Ecosystem Amendment Performance Measures Independent Scientific Review

Performance Measure 4.6: Doubling Goal for Central Valley Chinook Salmon Natural Production

Performance Measure 4.13: Barriers to Migratory Fish Passage

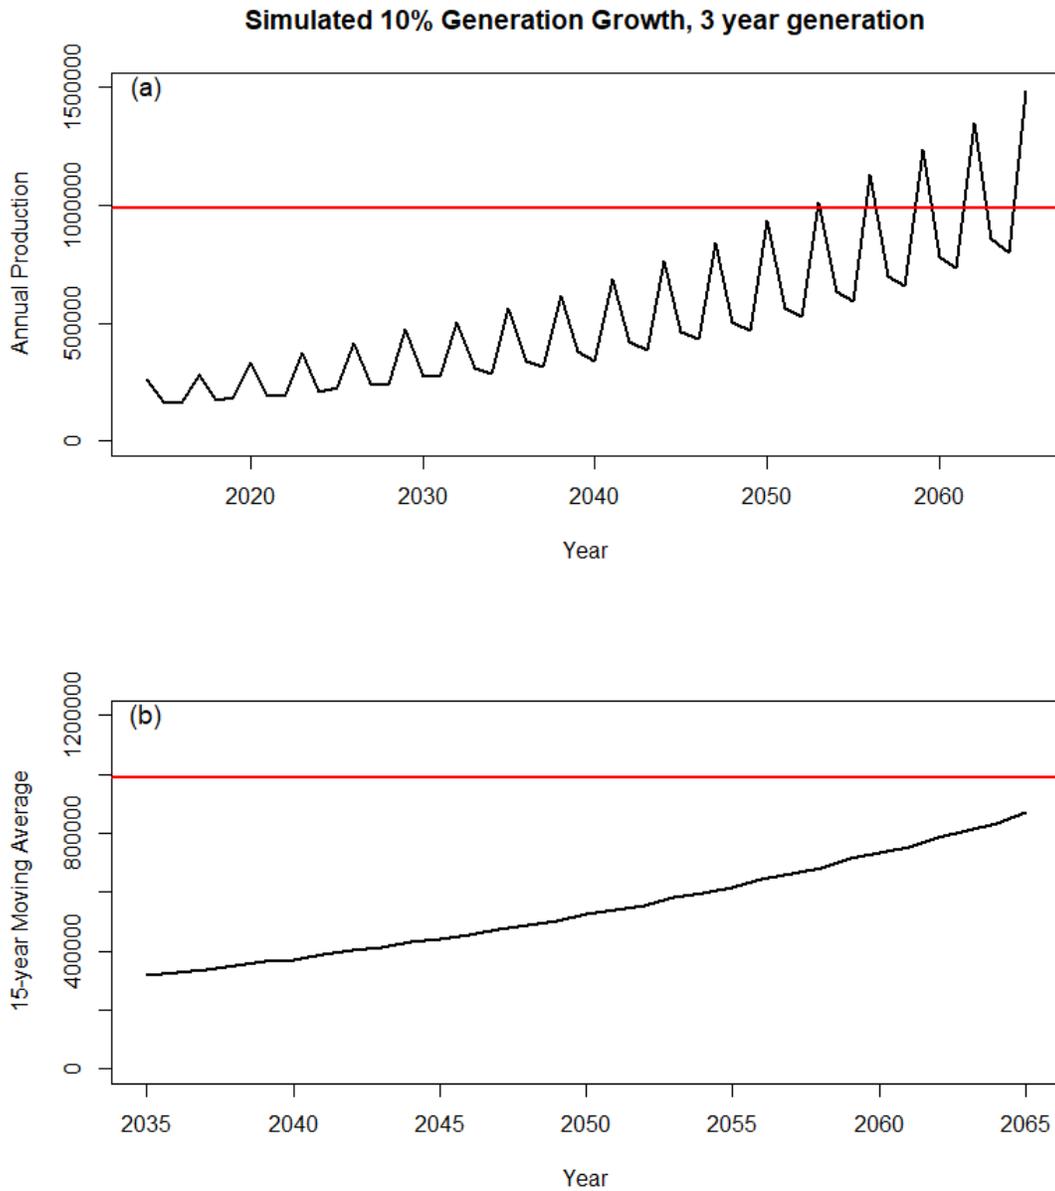
A simple simulation model that represents natural production as a cyclic process shows that even with 10% production increase between successive generations, the 15-year average is unlikely to reach the target of 990,000 by 2065 (Figure 1). The simulated production data in this model start from the 2014–2016 natural production estimates from ChinookProd (total for Central Valley, all runs combined), and use a cycle equal to a generation length of 3 years:

The annual production values in the simulated data pass the 990,000 target for the peaks of the 3-year cycles starting in 2053 (Figure 1(a)), but the 15-year moving average is simulated to reach only 870,764 by 2065 (Figure 1(b)). This model includes only autocorrelation effects of generation dependency (i.e., successive generations have similar size), random additive error on an annual basis, and population growth between generations. It omits a realistic spawner-recruit relationship, longer-term cyclic patterns, non-cyclic oceanic and climate patterns, climate change, effects of management or ecosystem change, and effects of catastrophic events. A more sophisticated model is required to adequately assess the feasibility of meeting the doubling goal target. However, this simple model shows that even very ambitious growth of 10% between generations may be insufficient to reach the doubling goal target. Meeting the secondary target of a positive slope of the 15-year moving average over 30 years is more attainable because it requires only a generally increasing population size. However, the trend in recent years has been a decline rather than growth, so even this target may be unattainable unless action is taken quickly.
